Revise the beaver Valley Unit No. 1 Technical Specifications as follows:

Revise the beaver Valley Unit No. 2 Technical Specifications as follows:

**Safety Analysis  
Beaver Valley Power Station  
Proposed Technical Specification Change  
BV-1 Change No. 174  
BV-2 Change No. 36**

**Description of Amendment Request:** The proposed amendment would modify the administrative control requirements by replacing applicable titles with the new titles developed for the Nuclear Group organization. The Plant Manager has been promoted to General Manager Nuclear Operations with responsibility for Maintenance, Chemistry, Onsite Safety Committee and Plant Operations. The administrative control sections have been revised to incorporate the following new titles:

FIGURE 13.1-2  
NUCLEAR GROUP  
DUQUESNE LIGHT COMPANY  
BEAVER VALLEY POWER STATION UNIT 2  
UPDATED FINAL SAFETY ANALYSIS REPORT

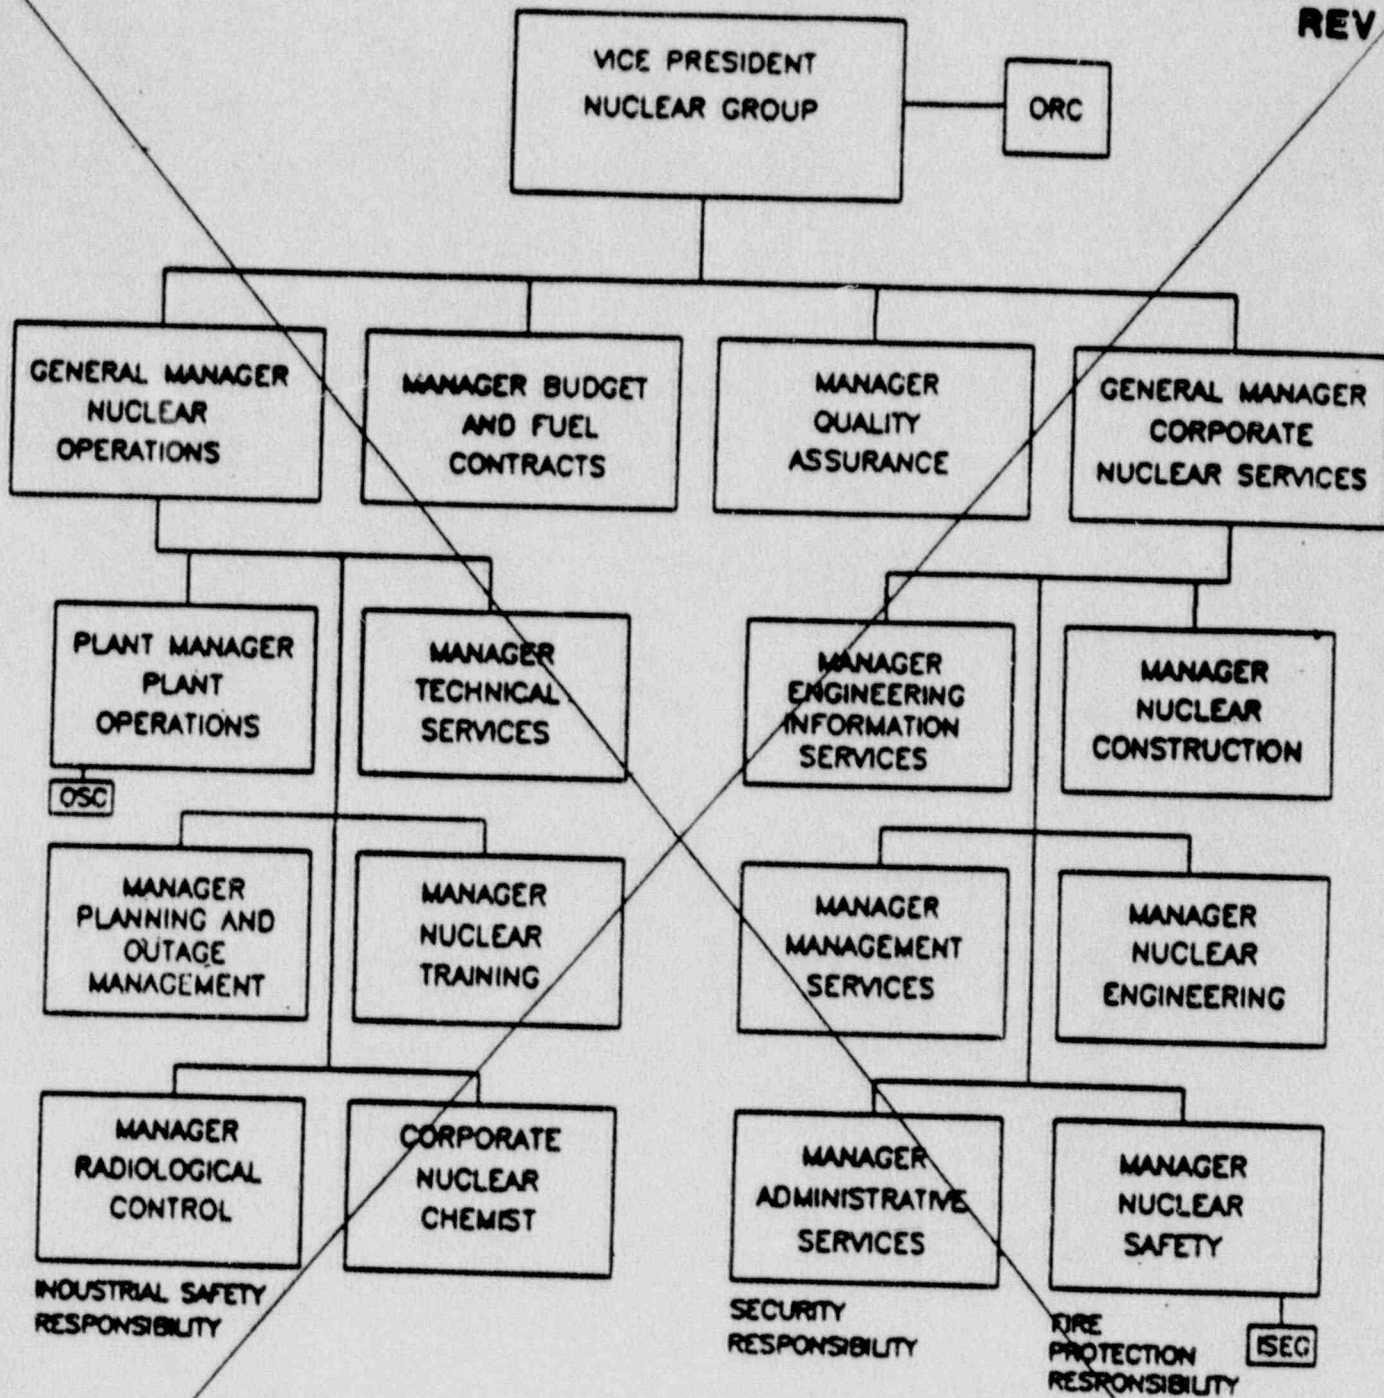
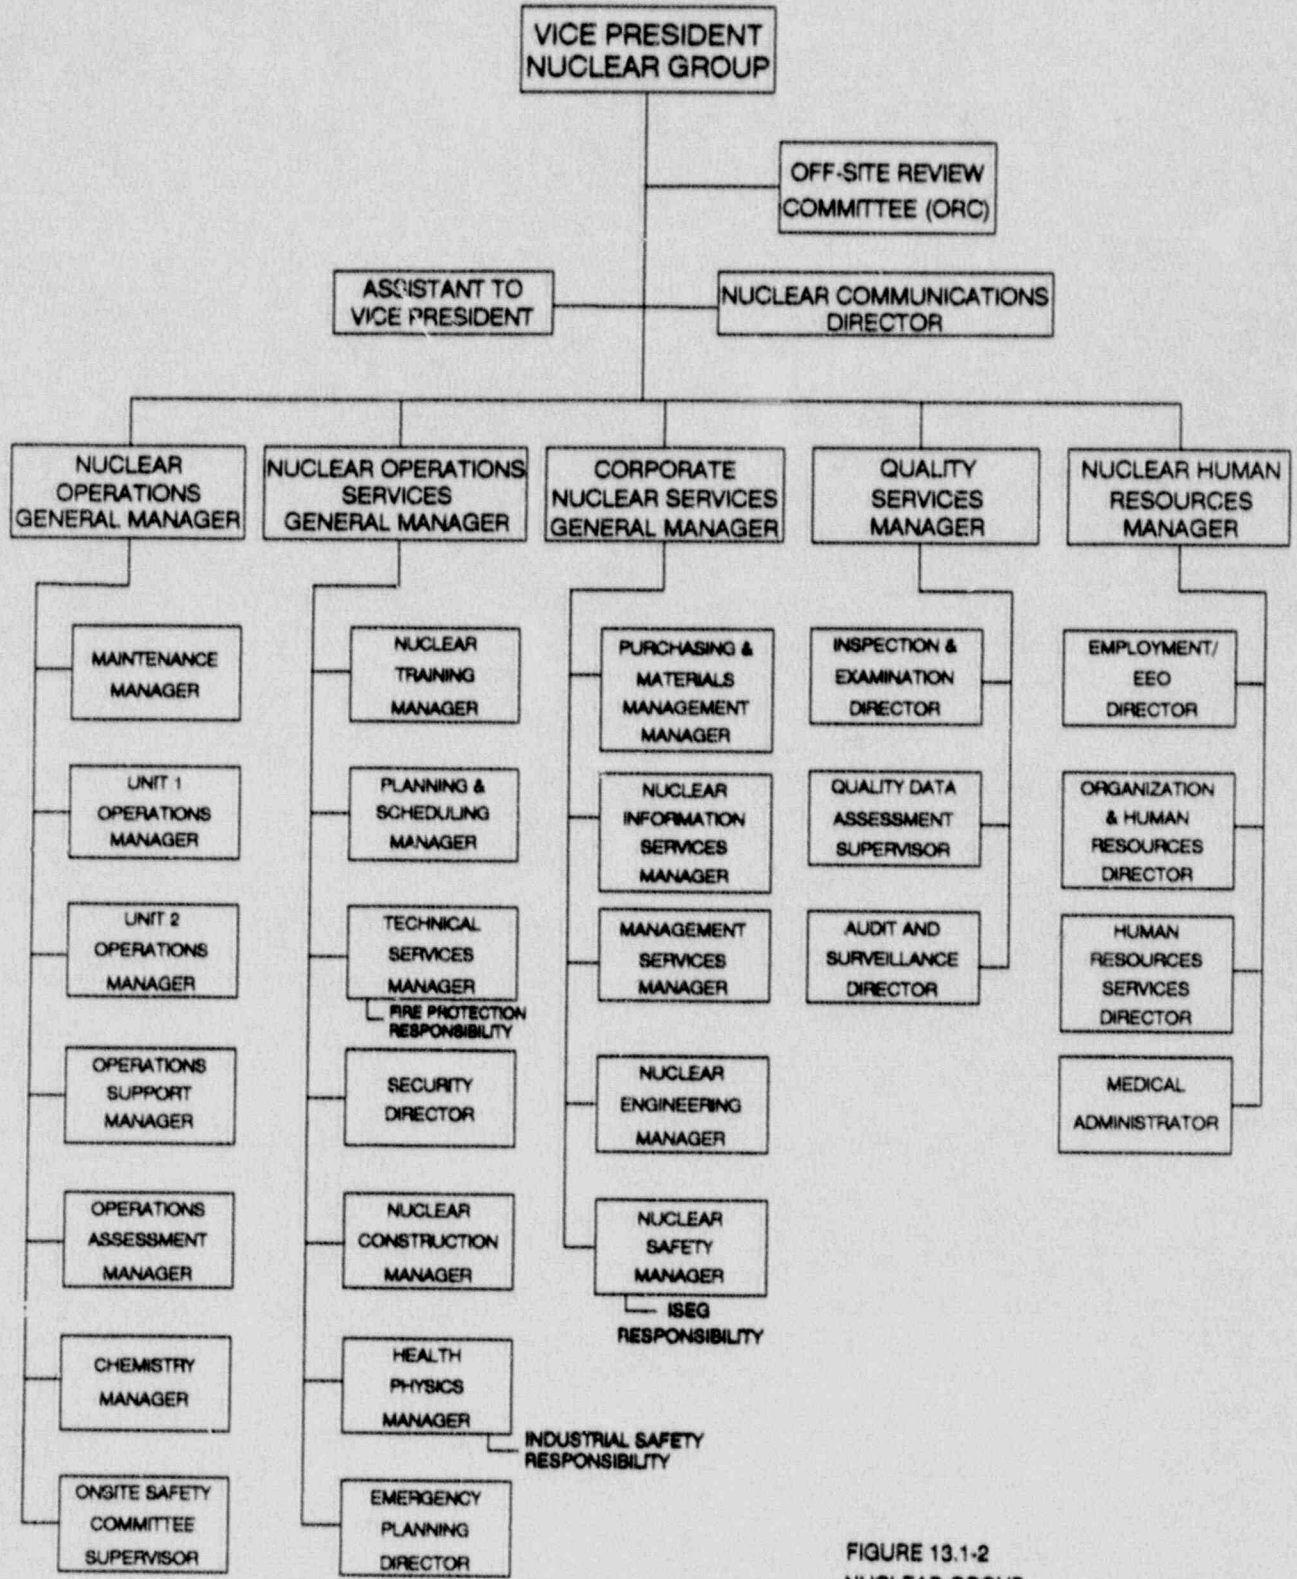
See Revised Figure Attached.

FIGURE 13.1-3  
STATION ORGANIZATION  
DUQUESNE LIGHT COMPANY  
BEAVER VALLEY POWER STATION - UNIT 2  
UPDATED FINAL SAFETY ANALYSIS REPORT

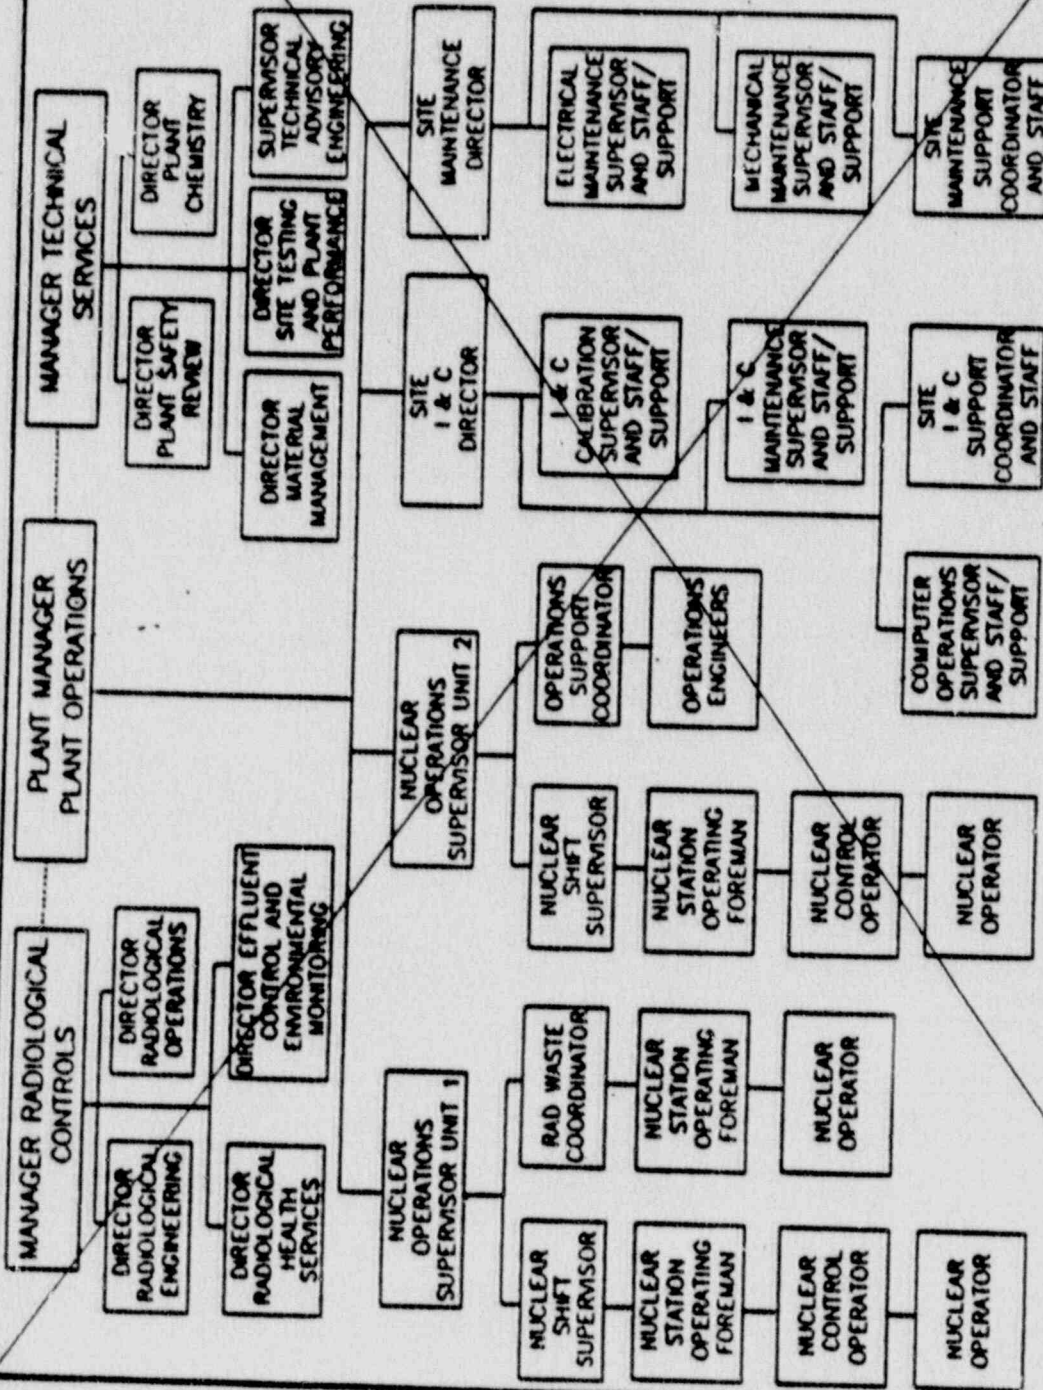
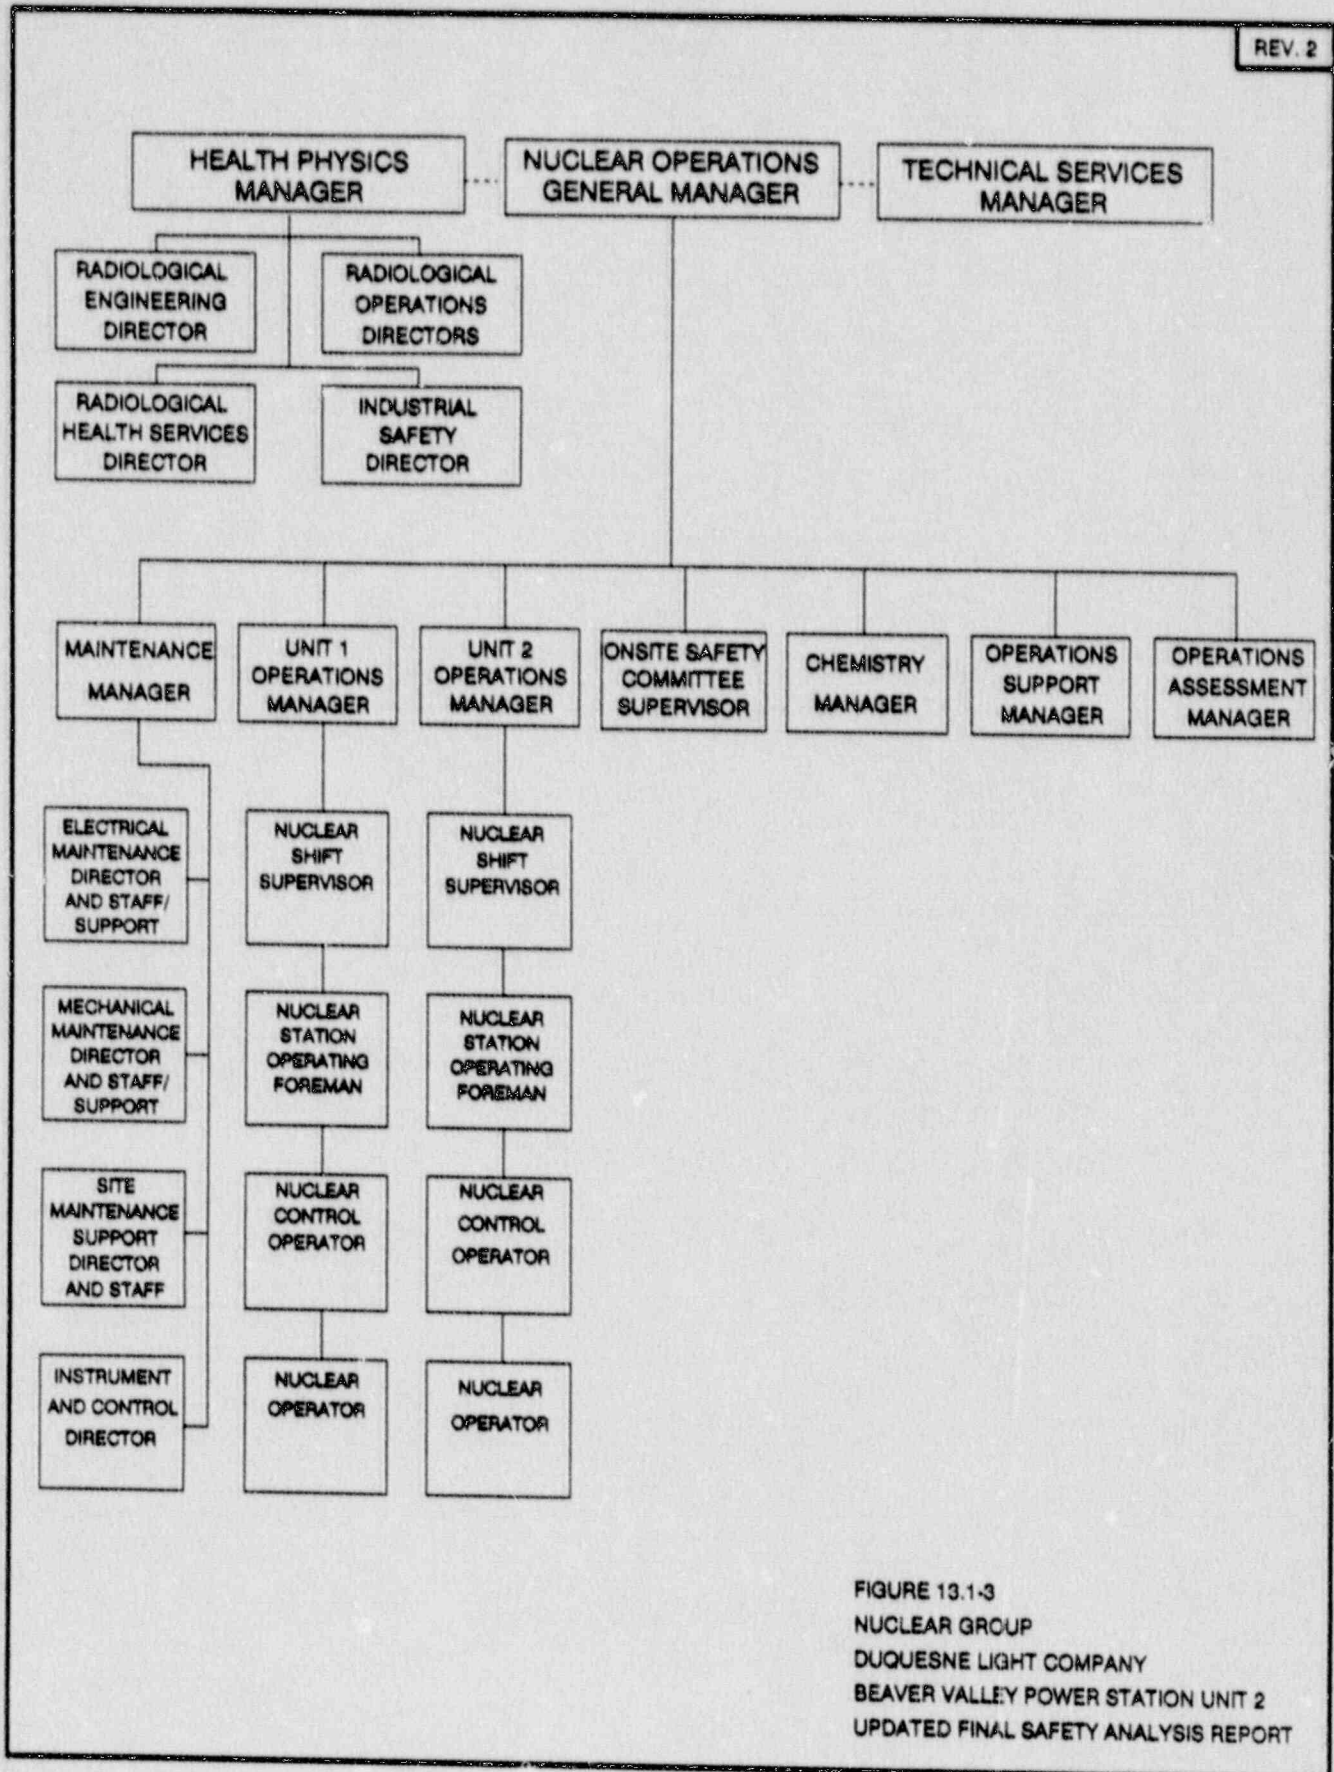
See Revised Figure Attached
